Ref. No. 201612007
Petition No. 1313

**REQUEST ENCROACHMENT
 INTO W. GRAND BLVD. AND THIRD AVE.
 AT 2921 W. GRAND BLVD.
 (With Planters and Sub-Surface Frost Slabs)**

CITY OF DETROIT CITY ENGINEERING DEPARTMENT SURVEY BUREAU	
JOB NO.	01-01
DRWG. NO.	X 1313

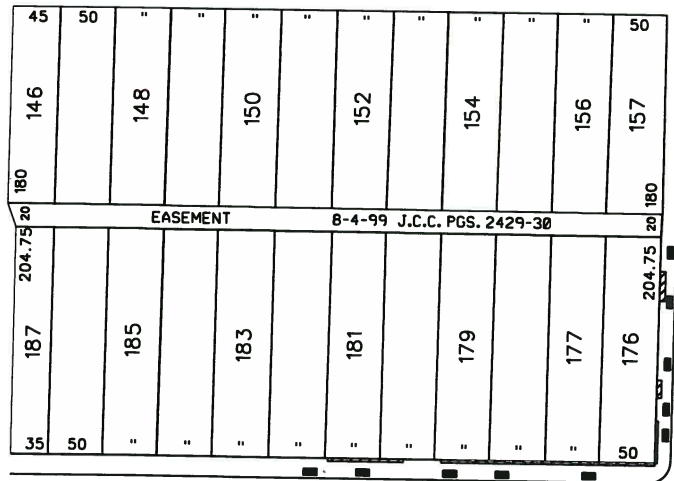
- (X) Involved; have no objection to the requested encroachment into W. Grand Blvd. and Third Ave. at 2921 W. Grand Blvd. (with planters and sub-surface frost slabs) as shown on drawing no. x1313 dated 12/09/2016 and revised on 2/2/2017 **except** for the encroachment with the proposed 16'x4' planter along the wall of the proposed building on the west side of Third Avenue since it affects the alignment of the sidewalk. The petitioner is requested to revise the request and resubmit it for review and approval by Traffic Engineering Division. The revised request should provide for a minimum clear sidewalk width of 6 ft. adjacent to the proposed planters for use by pedestrians at all times, and should not create obstruction to the straight alignment of sidewalk.
